GE
159 Plastics Avenue
Pittsfield, MA 01201
USA

August 25, 2006

**Re: GE-Pittsfield/Housatonic River Site
Hill 78 and Building 71 On-Plant Consolidation Areas (GECD210 & GECD220)
August 2006 Addendum to Phase II Final OPCA Cover Construction Plan**

SHEET TITLE: **KEYSTONE WALL SECTION, DESIGN VALUES**
CONSTRUCTION NOTES, & DETAILS

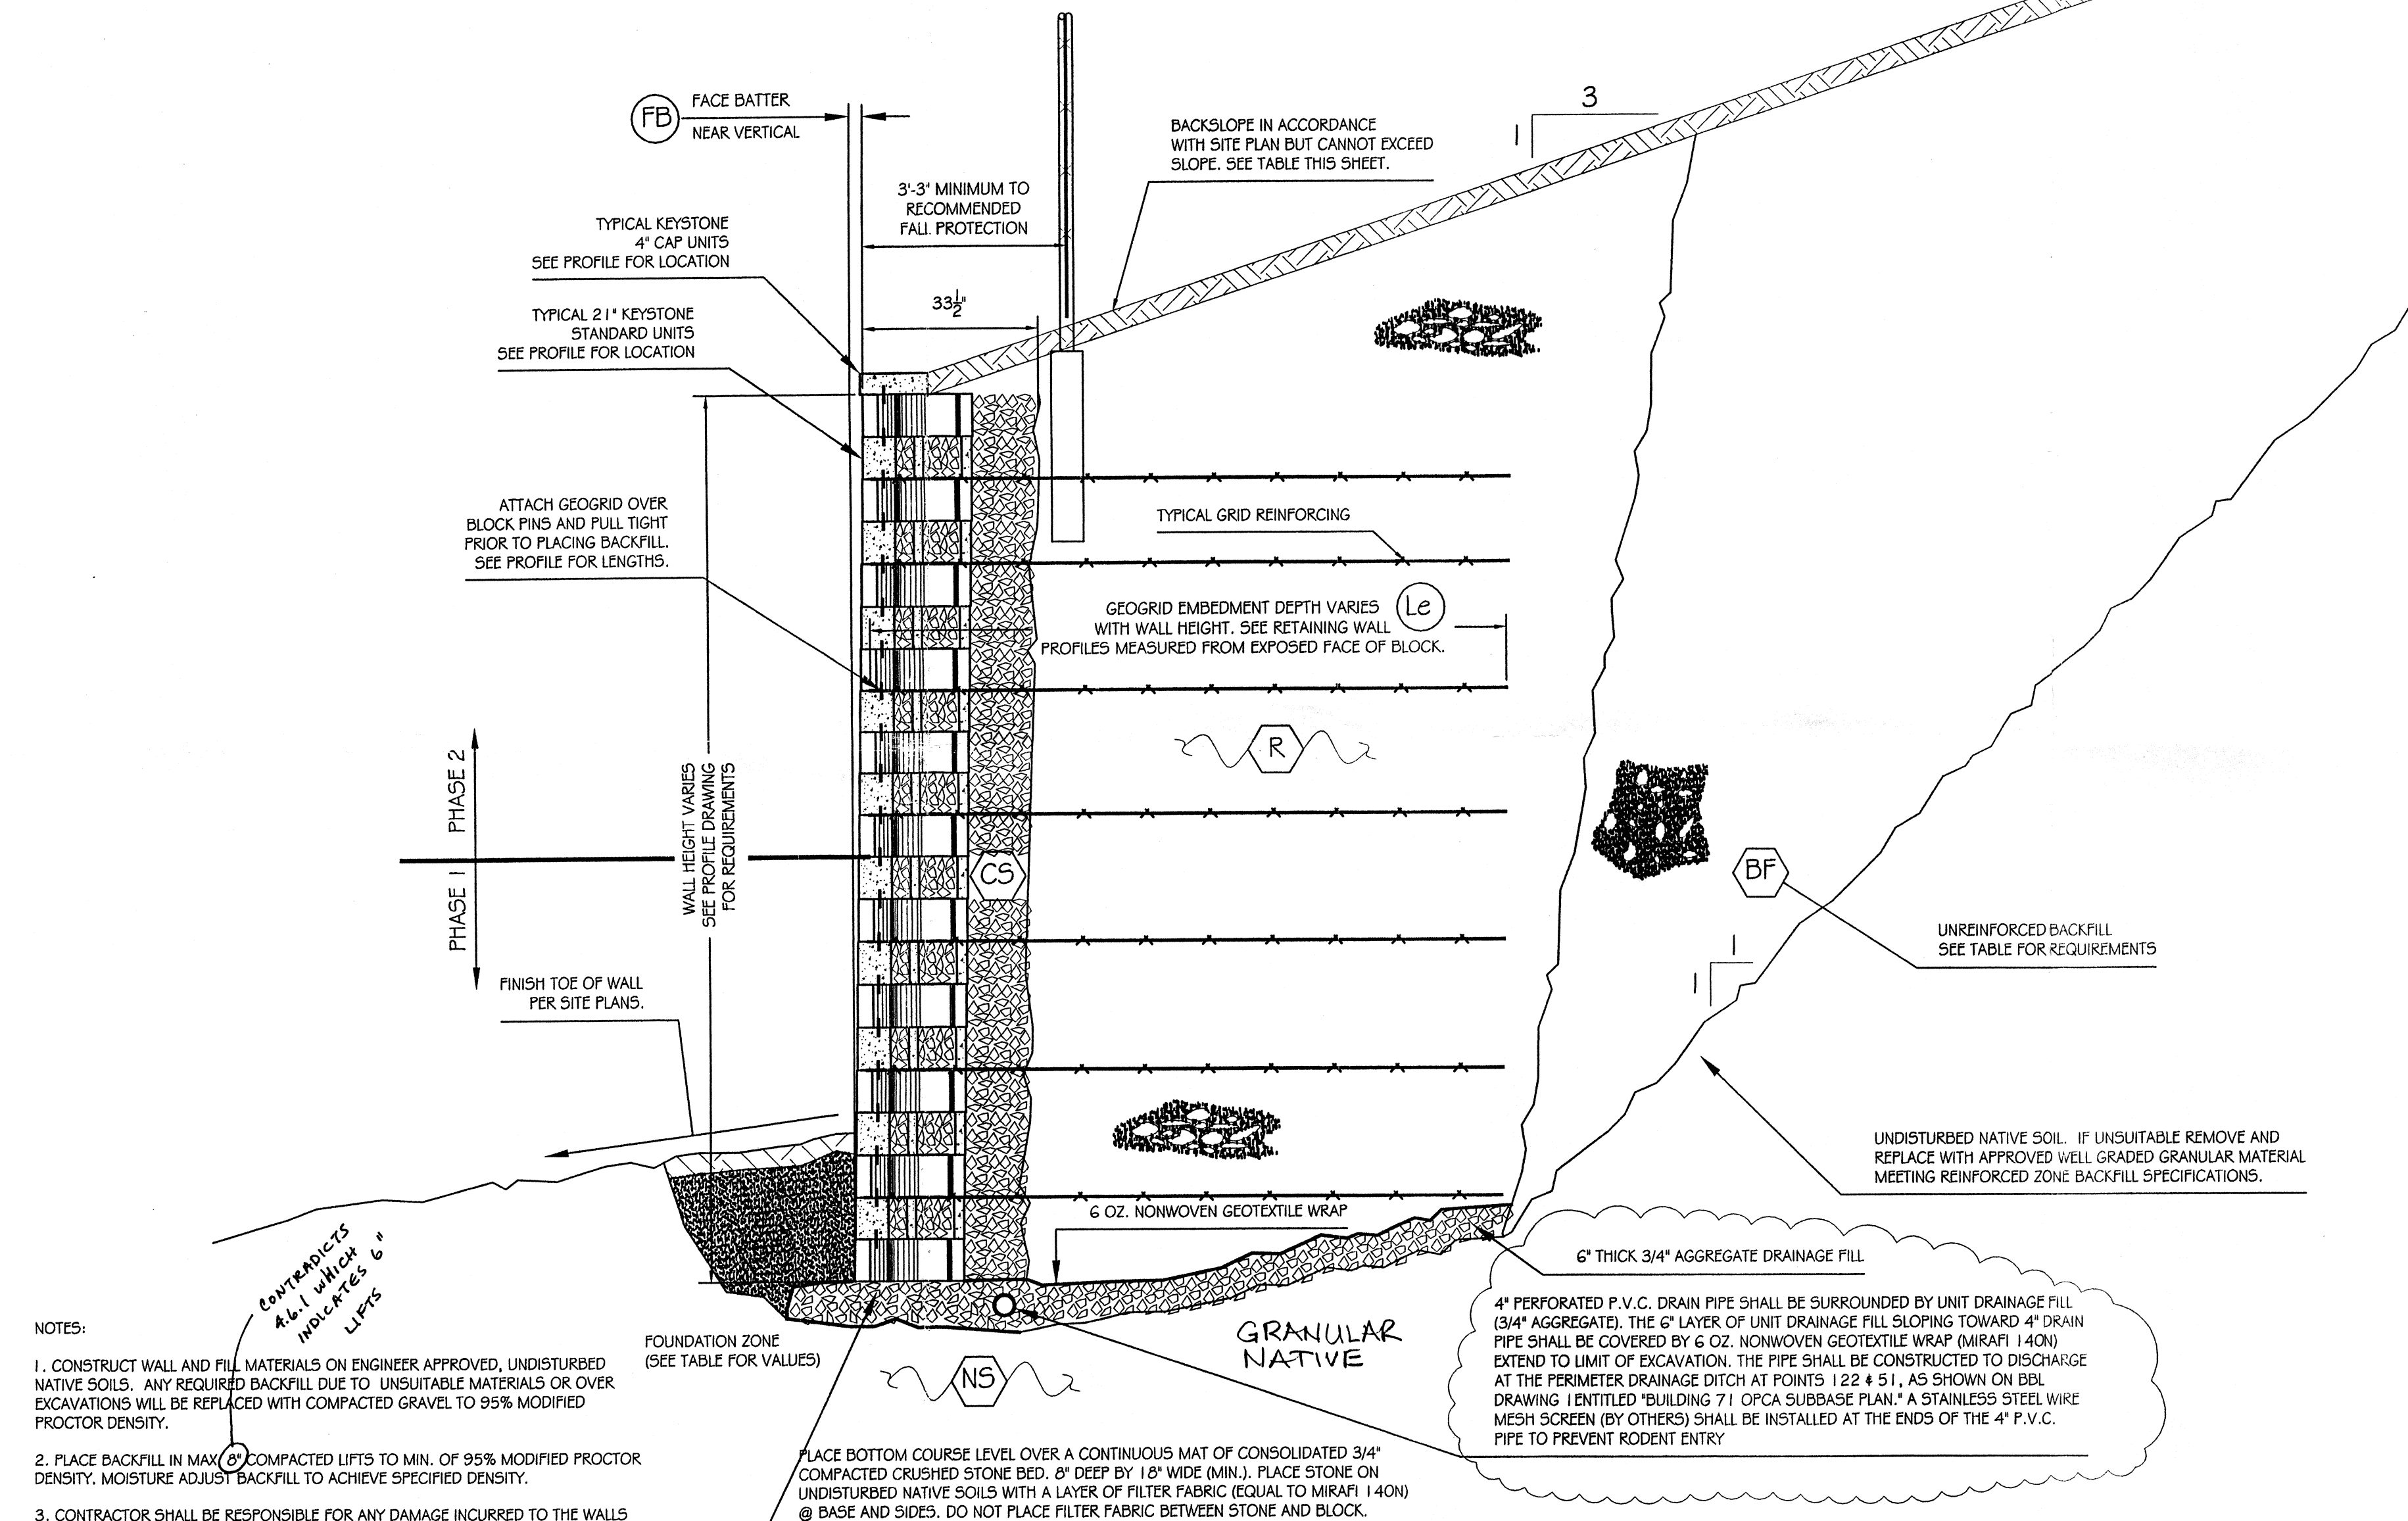
GE shall submit the design calculations for the retaining wall identified in Detail 2 of Drawing 9.

The design calculations for the retaining wall were prepared in November, 2002 by Associated Design Partners, Inc., a subcontractor to the retaining wall installer. The design calculations are included as Attachment A to this letter.
